# Service Bulletin

Bulletin Number: **SB 22-0016-MH-1MBTU**

Subject: IQ Screen Communication Loss

Product Line: Maxi Heat 1MBTU

Step 3- Relay 1

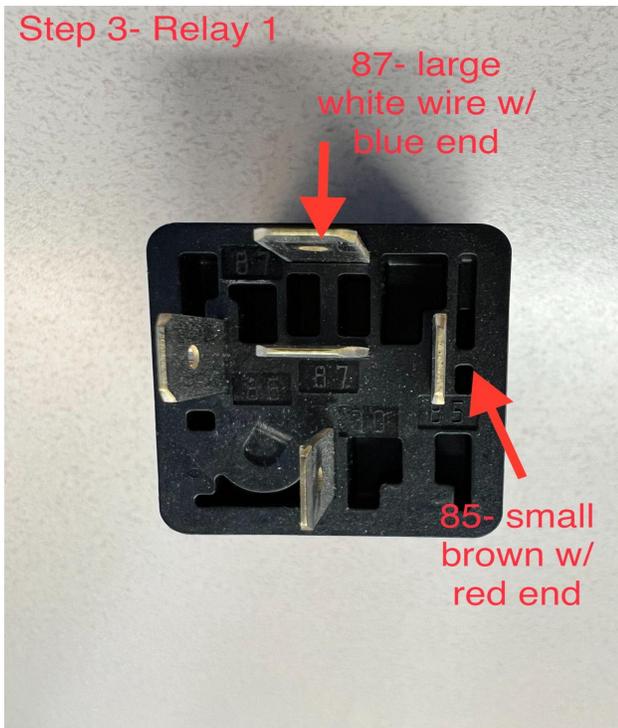
**Step 3: Relay 1-** Disconnect the large white wire with blue end. Next remove the small brown wire and connect it on terminal 85 where the white wire was connected. Move the large white wire to terminal 87, the same spot the brown wire was connected to. See page 5 for an additional image that depicts the correct orientation of the wires.

Step 4- Relay 2

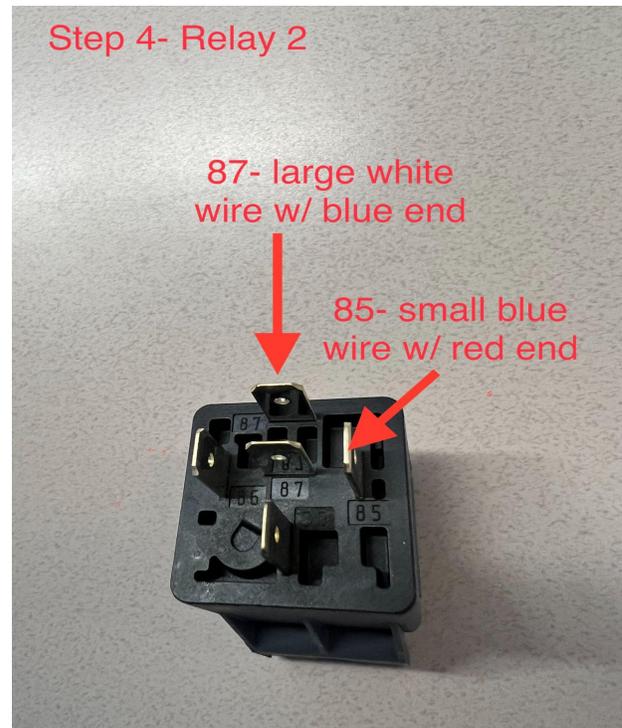
**Step 4: Relay 2-** Disconnect the large white wire with blue end. Next remove the small blue wire with red end and connect it to terminal 85, the same location as the white wire. Connect the white wire to terminal 87, the same place the blue wire was connected to. See page 5 for an additional image that depicts the correct orientation of the wires.

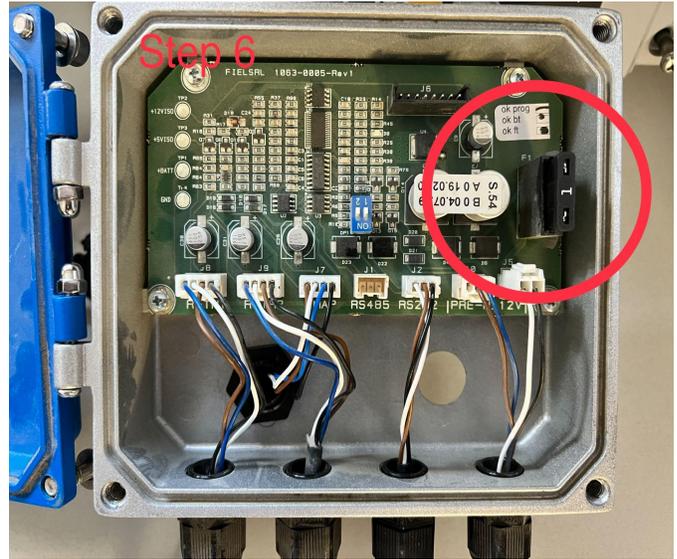
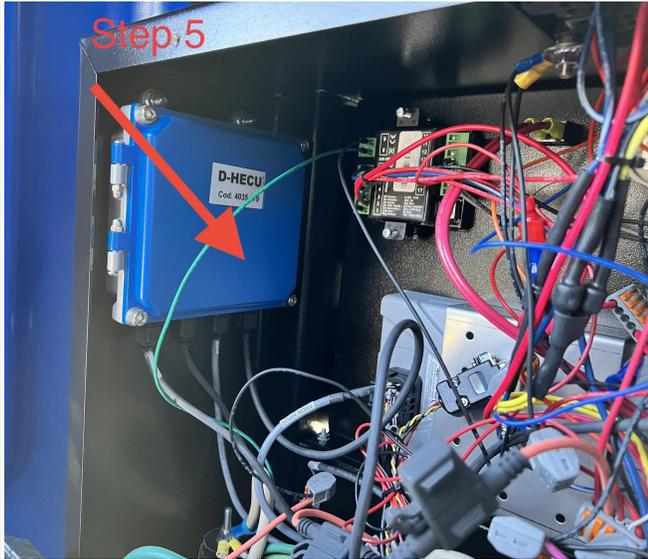
**Step 5:** Locate the DHECU box inside the breaker panel on the opposite side of the relays.

**Step 6:** Check the 1 amp fuse on the PC board. Replace if failed.
